INDUSTRIAL PRODUCTS DIVISION MARYLAND SHIPBUILDING & DRYDOCK CO. BALTIMORE, MD.	
MIDDLE SHELL ASSEMBLY CONDENSER 1B	
DESIGNED	CHECKED
DRAWN	APPROVED
TOTAL WEIGHT	SCALE
75,000 LBS.	1/2\"/>

D-3

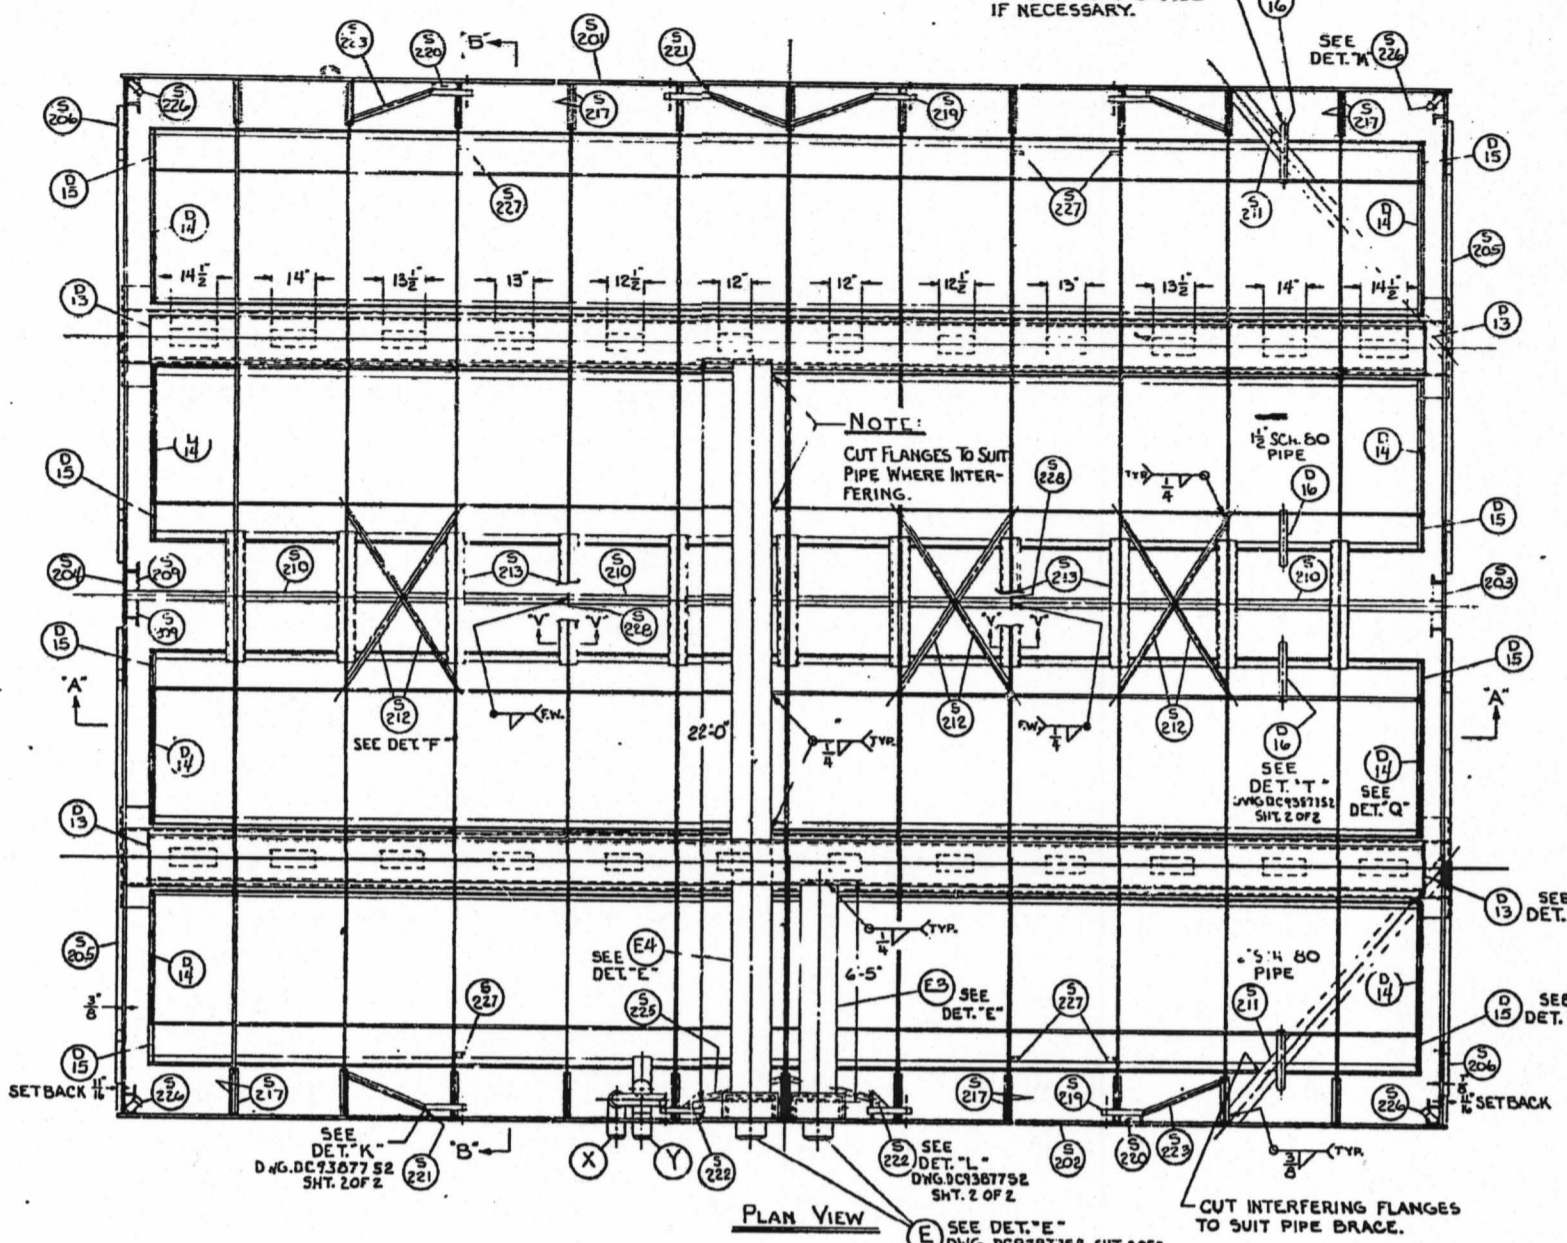
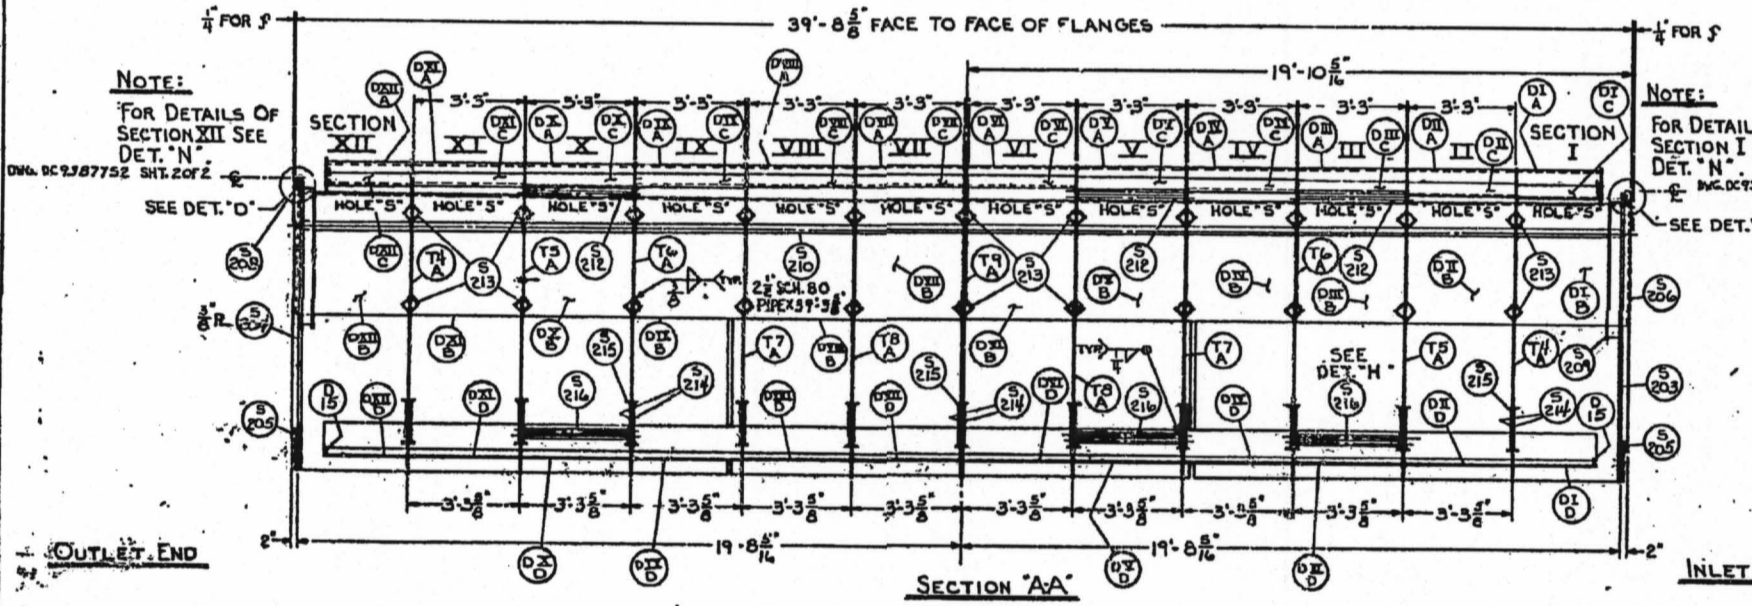
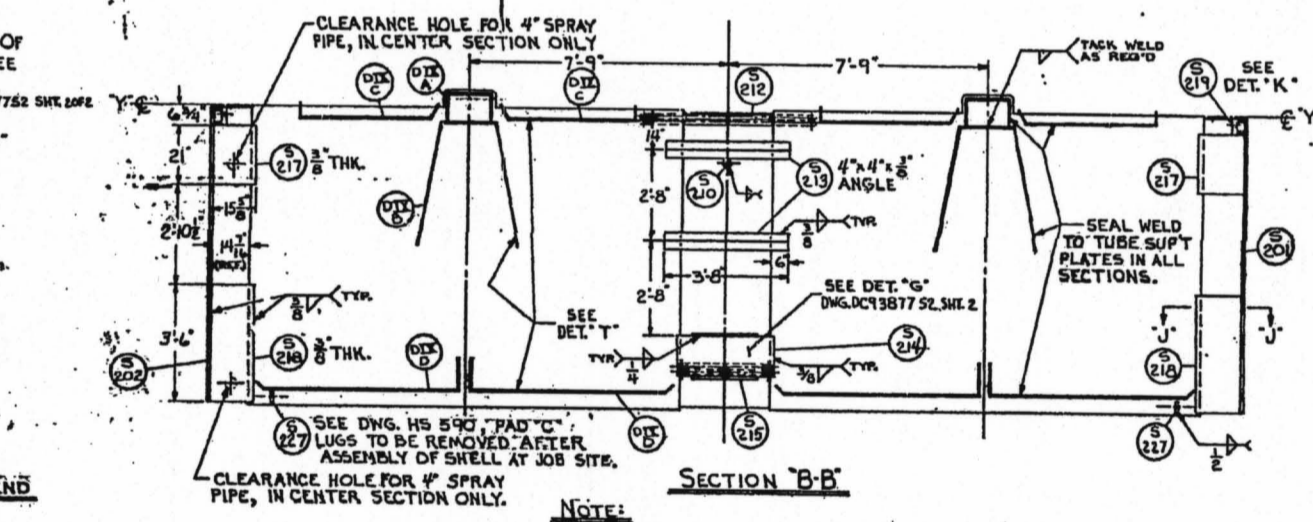
ALT.	DATE	REVISION	BY	CHK.
A	8/19/74	INCREASED LENGTH OF PG. NOS. D1B & D21L IN SECTIONS 1 & 2.	DCB	M
B	8/19/74	ADDED TOTAL WEIGHT AND WEIGHT PER SECTION. ADDED NOTES WITH INFORMATION ABOUT ADDITIONAL CONNECTIONS "CE", "CF", "CG", "CH" AND "CI".	DCB	M
